SUBJECT: ISSUANCE OF AMENDMENT NO. 169 TO FACILITY OPERATING LICENSE NO. DPR-35, PILGRIM NUCLEAR POWER STATION (TAC NO. M95324)

AMENDMENT NO. 169 TO FACILITY OPERATING LICENSE NO. DPR-35-PILGRIM NUCLEAR
POWER STATION

SAFETY EVALUATION BY THE OFFICE OF NUCLEAR REACTOR REGULATION
RELATED TO AMENDMENT NO. 169 TO FACILITY OPERATING LICENSE NO. DPR-35
BOSTON EDISON COMPANY
PILGRIM NUCLEAR POWER STATION
DOCKET NO. 50-293

PNPS
Figure 3.4-1

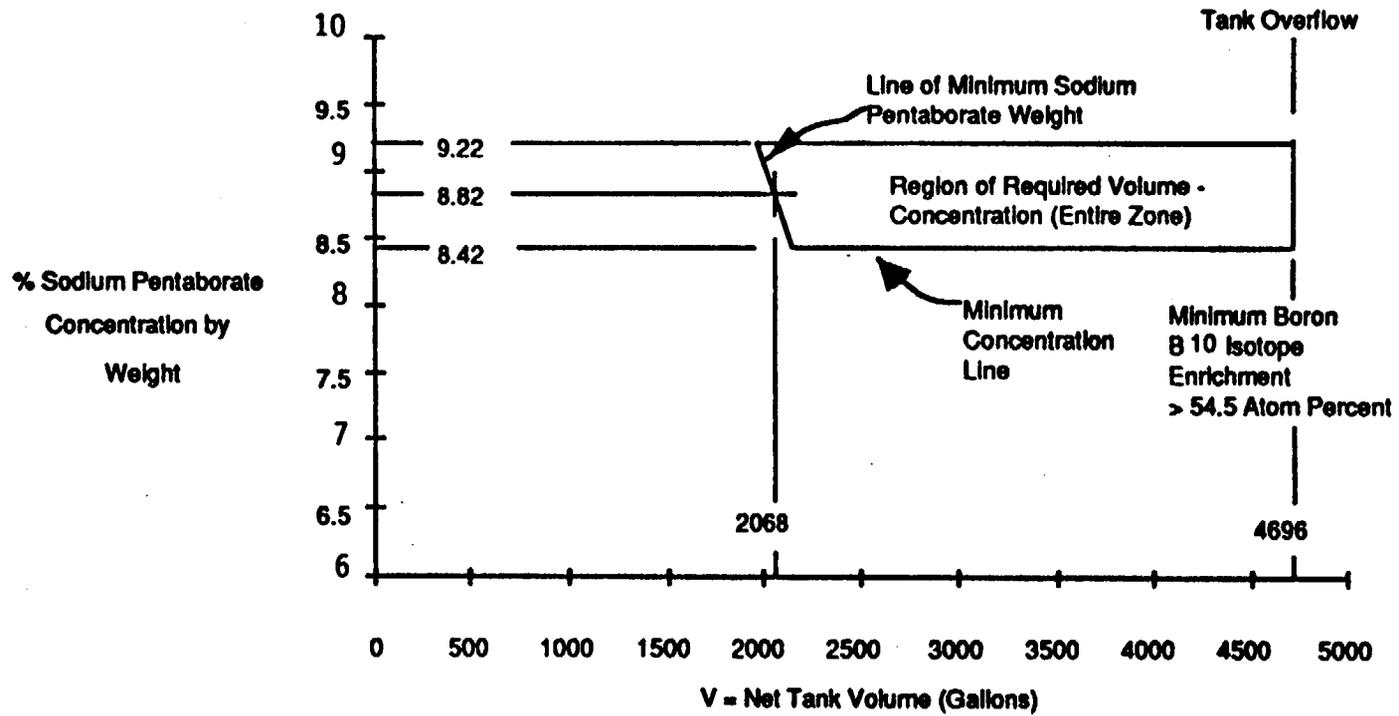
1. When tested as specified in 3.13 verify that each pump delivers at least 39 GPM against a system head of 1275 psig.
2. Manually initiate one of the Standby Liquid Control System loops and pump demineralized water into the reactor vessel every 24 months on a STAGGERED TEST BASIS.
3. Verify continuity of explosive charge every 31 days
4. Verify available volume of sodium pentaborate solution is within the limits of Figure 3.4-1 or ≥ 4000 gallons every 24 hours
5. Verify temperature of sodium pentaborate solution is $> 48^{\circ}$ F every 24 hours
6. Verify the concentration of boron in solution is ≤ 9.22 % weight and within the limits of Figure 3.4-1 every 31 days;

7. Verify sodium pentaborate enrichment is ≥ 54.5 atom percent B-10 prior to addition to SLC tank
8. Verify all heat traced piping between storage tank and pump suction is unblocked every 24 months
